Intersection ID: 3350	Main Street: FALLS_RIDGE_LN	Cross Street: CANIPE_DR	Location:	NE
ADA ID: 9B3A8CBF0C0E	Ramp Type: BlendTrans1	Initial Pass/Fail: Fail	Overall Compliance: No	Severity Score: 25

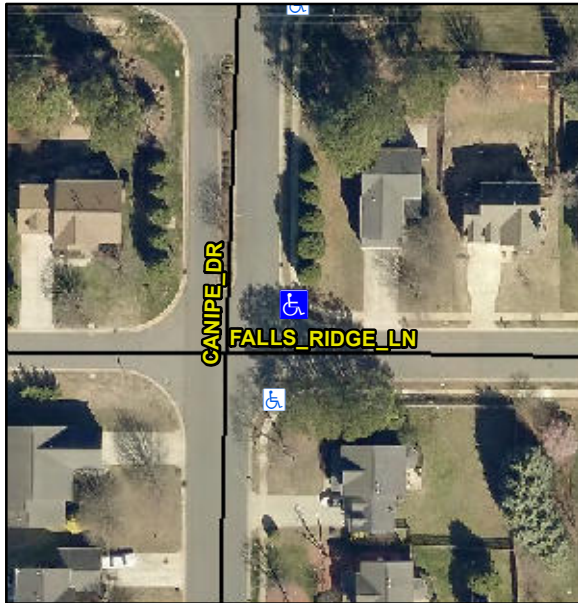
**Not Found, R304.5.3**

Compliance	Description	Data	Compliance	Description	Data
N/A	Ramp Length (in)	47.5	Yes	BlendTrans Slope (%)	3.2
Yes	Ramp Width (in)	60.0	No	BlendTrans XSlope (%)	7.6
N/A	Flare Type LT	N/A	N/A	Flare Type RT	N/A
N/A	Flare Slope LT (%)	N/A	N/A	Flare Slope RT (%)	N/A
N/A	Flare Traversable LT?	N/A	N/A	Flare Traversable RT?	N/A
N/A	Landing Length (in)	N/A	N/A	DWS Provided?	N/A
N/A	Landing Width (in)	N/A	N/A	DWS Contrast?	N/A
N/A	Landing Slope (%)	N/A	N/A	DWS Length (in)	N/A
N/A	Landing X Slope (%)	N/A	N/A	DWS Full Width?	N/A
N/A	Landing Curb? (Y/N)	N/A	N/A	DWS Offset (in)	N/A
N/A	Shared Landing?	N/A			
N/A	Gutter Ponding?	N/A	N/A	Gutter Slope (%)	N/A
N/A	Gutter Lip Ht (in)	N/A	N/A	Gutter X Slope (%)	N/A
N/A	Painted X Walk1?	No	N/A	Painted X Walk2?	N/A
	X Walk 1 Direction	To S		X Walk 2 Direction	N/A
	X Walk 1 Width (in)	N/A		X Walk 2 Width (in)	N/A
	X Walk 1 Slope (%)	2.8		X Walk 2 Slope (%)	N/A
	X Walk 1 X Slope (%)	7.8		X Walk 2 X Slope (%)	N/A

N/A	Ramp inside XWalk1?	N/A	N/A	Ramp inside XWalk2?	N/A
	Road Slope (%)	7.8		Clear Space?	N/A
	Road X Slope (%)	2.8	N/A	Clear Space to XWalk (in)	N/A
N/A	Any Obstructions?	N/A	N/A	Storm Grate/Utility Hazard?	N/A
	Obstruction Type			Storm Grate/Utility Type	
		N/A			N/A
			Yes	Surface Condition? (G/P)	Good
			No	Curb Slope (%)	11.4

**Remove & Replace Curb Ramp With Two New Directional Ramps or Equivalent.**
